UNITED STATES PATENT AND TRADEMARK OFFICE

APPLICATION NO.	FILING DATE	FIRST NAMED INVENTOR	ATTORNEY DOCKET NO.	CONFIRMATION NO.
10/658,154	09/08/2003	Mark L. Burgener	PER-005-PAP	5658
7590 08/10/2005			EXAMINER	
JAQUEZ & ASSOCIATES			ENGLUND, TERRY LEE	
Suite 1000			ART UNIT	
6265 Greenwich Drive			PAPER NUMBER	
San Diego, CA 92122-5916			2816

Office Action Summary

DETAILED ACTION

FIG. 1

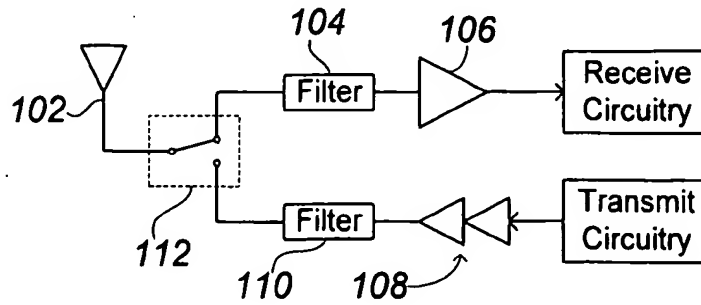
The replacement sheet for Fig. 1 overcame its objection, and the applicants' comments on page 18 of the amendment overcame the objection to Fig. 2 by indicating the figure "contains material that is not known to be in the prior art. The architecture is "basic" only in that it omits switching details." Therefore, the drawing objections described in the previous Office Action have been withdrawn.

Figure 1 has been amended in response to the Examiner's objections thereto by addition of the term "Prior Art" as requested. A replacement first drawing sheet incorporating these changes, together with an annotated first drawing sheet showing changes in red, are attached to this response as an appendix.
